GRID-UPGRADING IN SELECTED ISLANDS IN THE MALDIVES

RFB No: MV-MEE-266363-CW-RFB

**Accelerating Renewable Energy Integration and
Sustainable Energy (ARISE) Project**

Clarifications 02

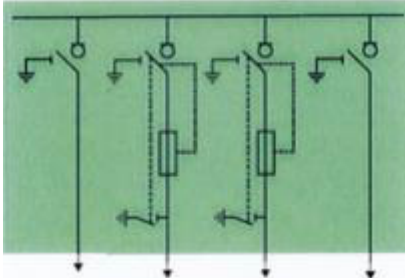
Item No.	Reference / Quoted Text	Clarifications / Question	Responses / Confirmation / Addendum
2.7	Section VII - Appendix B 5.2 ADDU City 	Please clarify which kind of devices the red arrow point to it is?	Fuse
